RE: **Palen Solar Power Project, Docket No. 09-AFC-7**
Responses to January 14, 2010 CEC Workshop Queries
Technical Areas:
Soil & Water Resources (supplemental data for DR-S&W-242)

Palen Solar Power Project

Soil and Water Data Responses to January 14, 2010 CEC Workshop Queries

DR#242 Supplemental---Soil and Water:

Soil & Water Figures

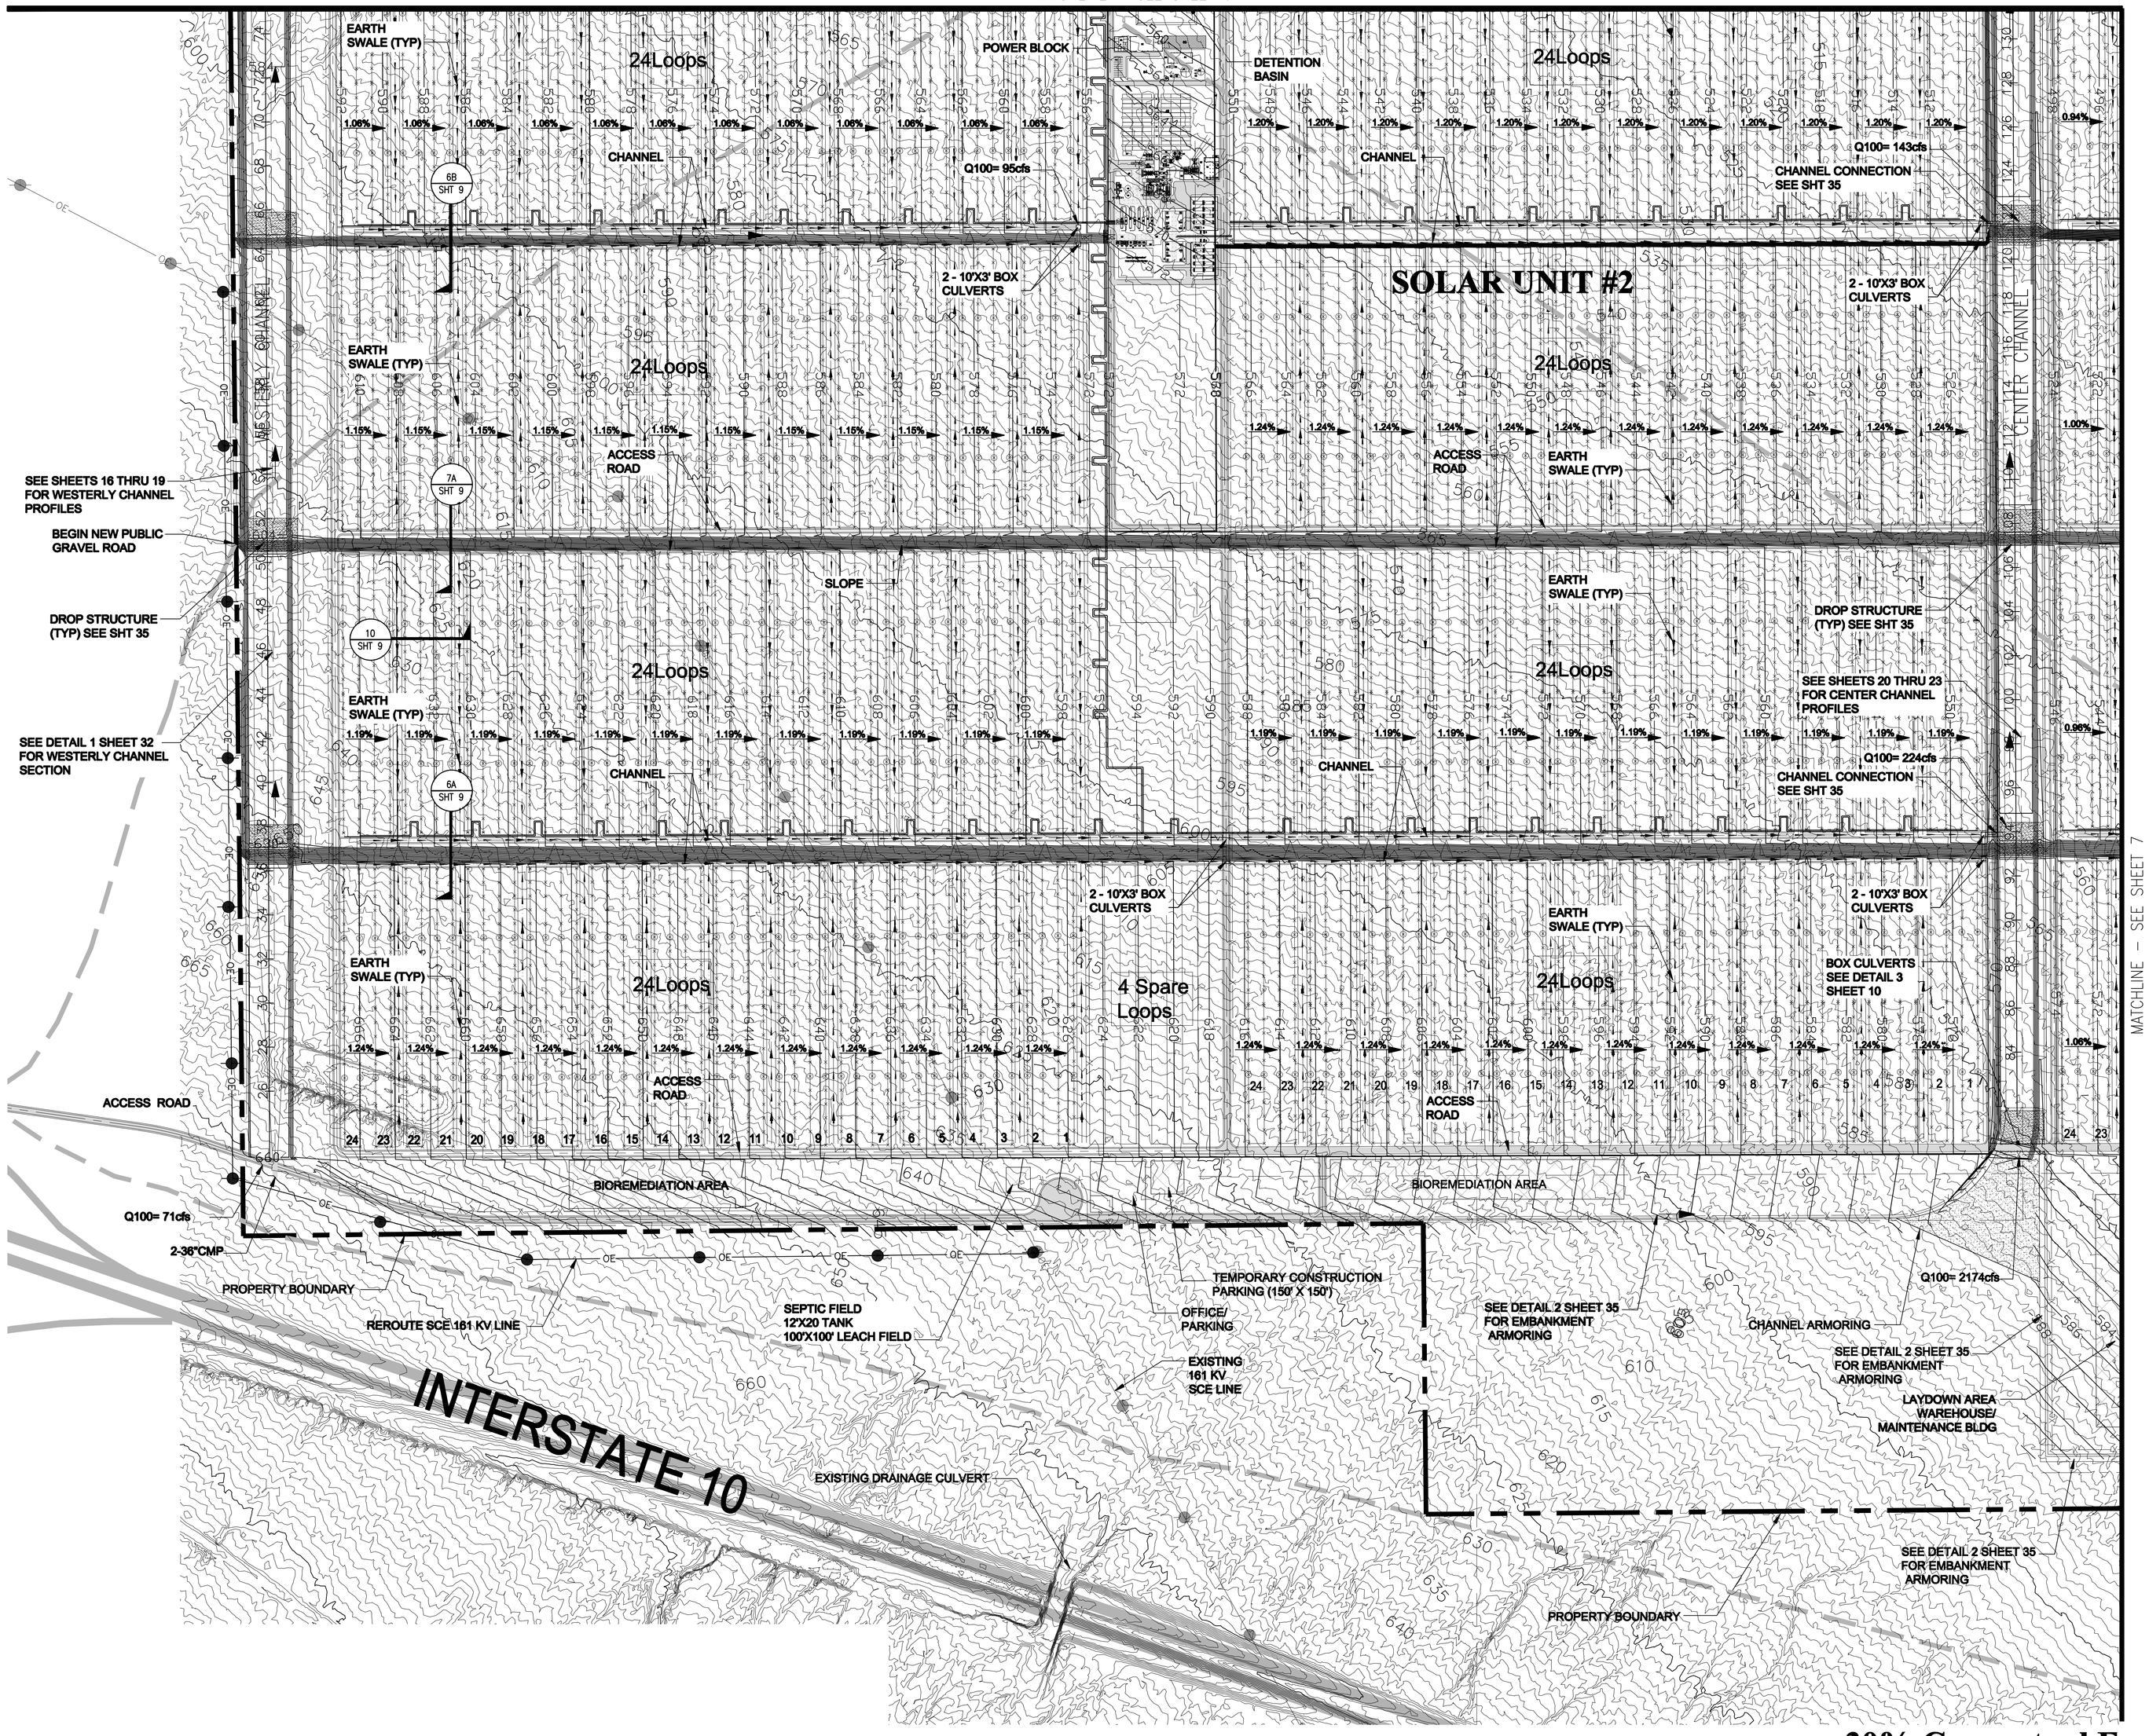
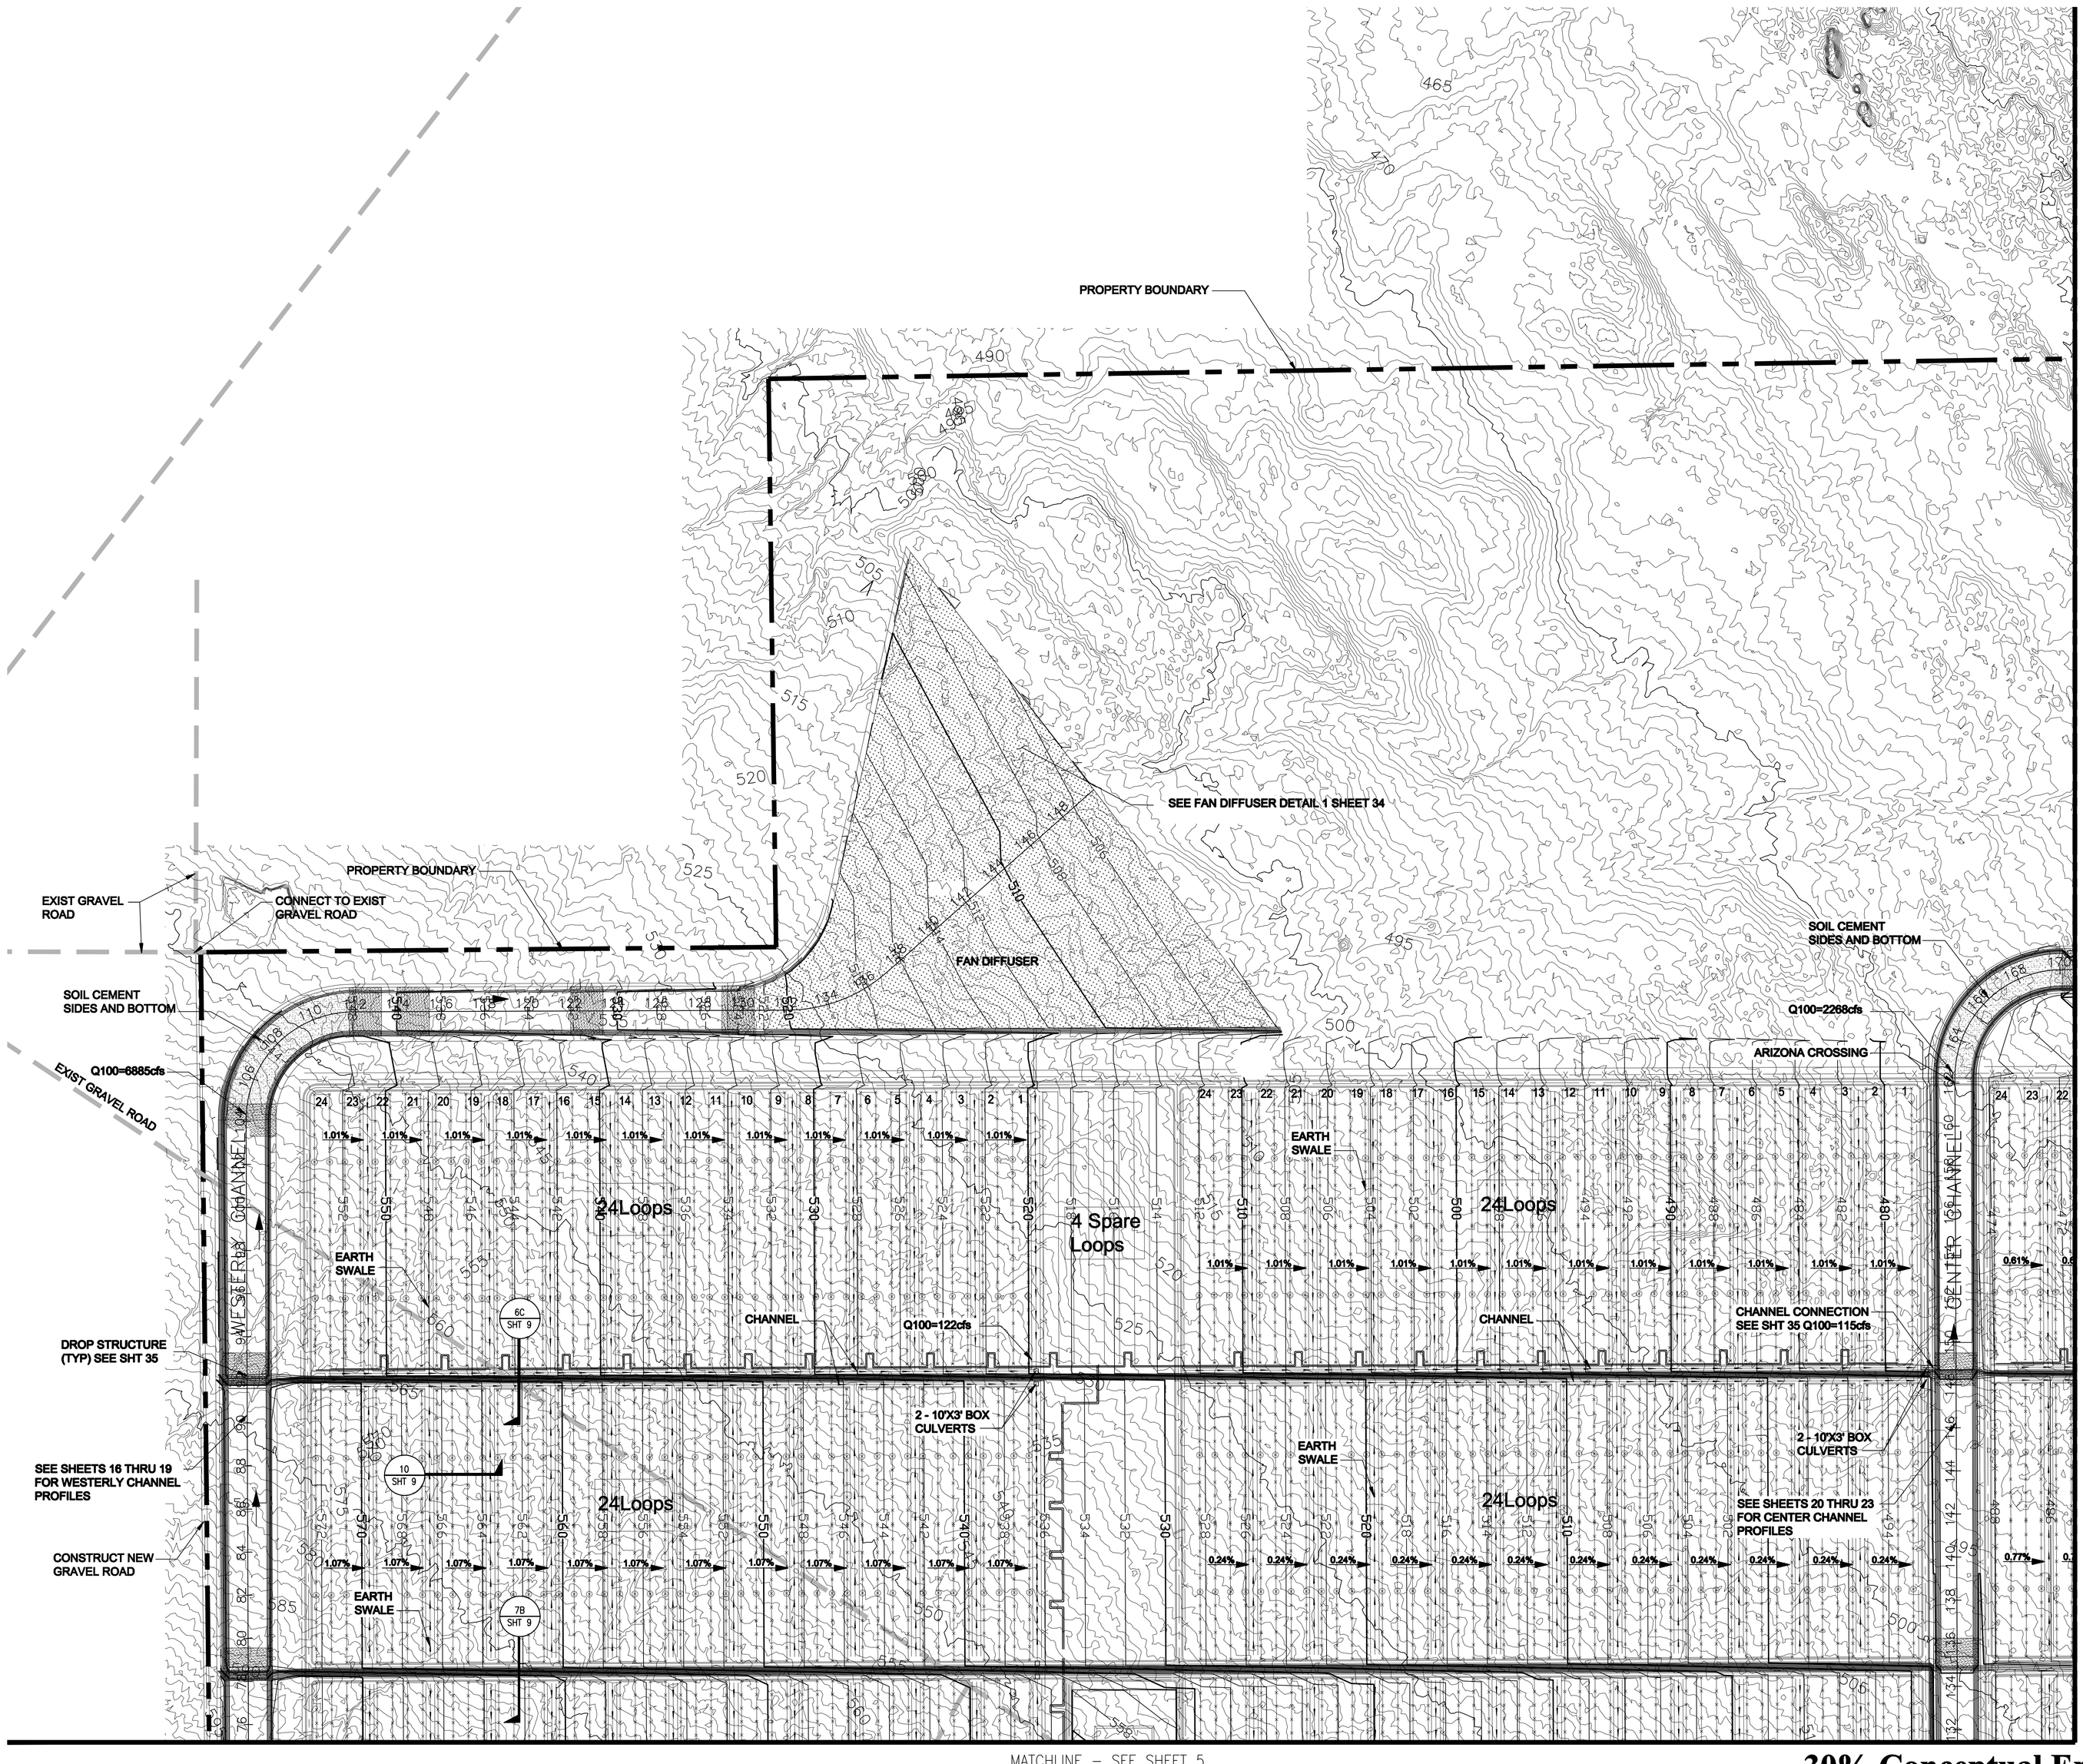
Add channel stationing on plan view drawings to match channel profile drawings (DR-S&W-242).

Add 1 ft contours to Palen post-development drainage drawings; drawings currently show only 5 ft contours.

Channel stationing is being added to the plans and will be provided as part of this response. Channel stationing is shown on the grading sheets 5-8.

The 1-foot contours have been added to the plans and are being provided as part of this response. The contours are shown on sheets 5-8.
